Re: Case Ref. PAX21.324561 – Crumhach Wind Farm, Co. Sligo – SSE Renewables (Ireland) Ltd.

I, Declan Dunleavy, wish to make an observation on the proposed Crumhach Wind Farm under Section 37E of the Planning and Development Act 2000, as amended. The prescribed fee of €50 is paid online. Supporting documents are attached as Appendices A to D.

Appendix D: Photomontage from Viewpoint 14 (Doonbeakin)

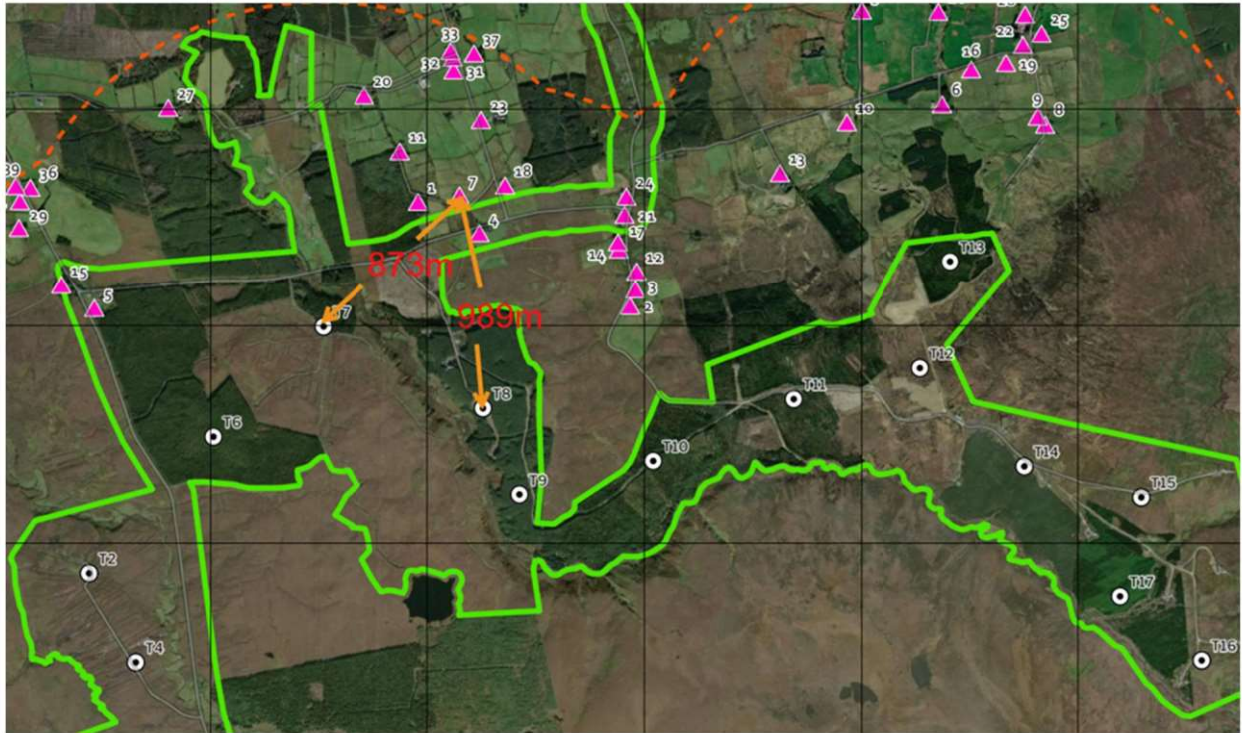
- 6.3 That is the Council's own professional view of this landscape, and it applies equally to this proposal. The applicant's photomontages show the tops of 9 turbines visible from Lough Easky. My recollection of the pre-planning meeting is that the Council's planners were not in favour of any turbines being visible from this location. In addition, no photomontages are provided along the Scenic Route between the waterworks and Lough Easky, or at the historic structure known locally as Coopers Lodge. This is the section of the route that would be most affected, as T6, T2, T4, T1, T3 and T5 lie directly along it. I ask that the applicant be required to provide photomontages from this section of the Scenic Route.
